Access Compliance Report

Public Rights-of-Way

(Curb Ramps)

Intersection ID: 17609	Main Street: E_WOODLAWN_RD	Cross Street: STERLING_DR	Location:	NE
ADA ID: 8B6E8BC2AC4C	Ramp Type: PerpDiag	Initial Pass/Fail: Pass	Overall Compliance: No	Severity Score: 12.5
Codes/Mitigation Info/Possible Solution		Field Measurements/Component Compliance

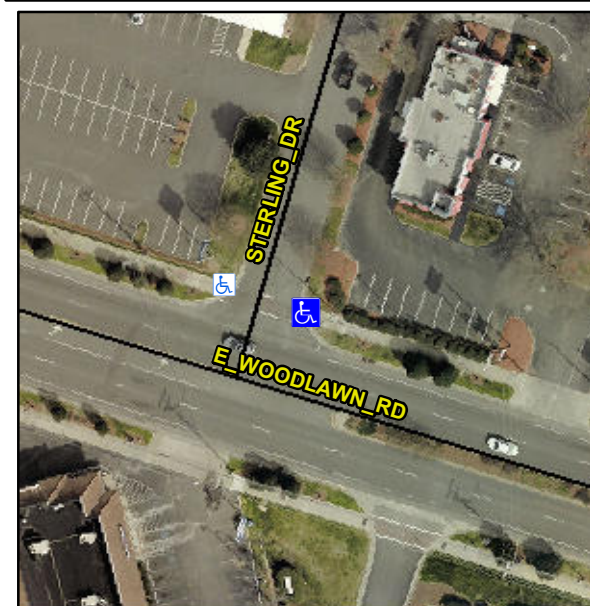
R304.2.1, R304.2.2-Perp, R304.3.2-Para, R304.5.3, R305.1.4

Compliance	Description	Data	Compliance	Description	Data
N/A	Ramp Length (in)	50.0	Yes	Ramp Slope (%)	6.1
Yes	Ramp Width (in)	48.0	Yes	Ramp XSlope (%)	0.5
N/A	Flare Type LT	Sloped	N/A	Flare Type RT	N/A
N/A	Flare Slope LT (%)	2.4	Yes	Flare Slope RT (%)	0.0
N/A	Flare Traversable LT?	Yes	N/A	Flare Traversable RT?	Yes
No	Landing Length (in)	N/A	Yes	DWS Provided?	Yes
No	Landing Width (in)	N/A	Yes	DWS Contrast?	Yes
No	Landing Slope (%)	N/A	Yes	DWS Length (in)	24.5
No	Landing X Slope (%)	N/A	No	DWS Full Width?	No
N/A	Landing Curb? (Y/N)	No	Yes	DWS Offset (in)	1.0
N/A	Shared Landing?	N/A			
Yes	Gutter Ponding?	No	Yes	Gutter Slope (%)	2.6
Yes	Gutter Lip Ht (in)	0.0	No	Gutter X Slope (%)	3.1
N/A	Painted X Walk1?	Yes	N/A	Painted X Walk2?	No
	X Walk 1 Direction	To NW		X Walk 2 Direction	To SW
N/A	X Walk 1 Width (in)	105.0	N/A	X Walk 2 Width (in)	N/A
	X Walk 1 Slope (%)	0.8		X Walk 2 Slope (%)	2.7
	X Walk 1 X Slope (%)	3.1		X Walk 2 X Slope (%)	1.4

Yes	Ramp inside XWalk1?	Yes	N/A	Ramp inside XWalk2?	N/A
	Road Slope (%)	2.1	N/A	Clear Space?	Yes
	Road X Slope (%)	2.2	N/A	Clear Space to XWalk (in)	N/A
Yes	Any Obstructions?	No	Yes	Storm Grate/Utility Hazard?	No
	Obstruction Type			Storm Grate/Utility Type	
		N/A			N/A
			Yes	Surface Condition? (G/P)	Good

Remove & Replace Curb Ramp With Two New Directional Ramps or Equivalent. Remove & Replace Gutter.
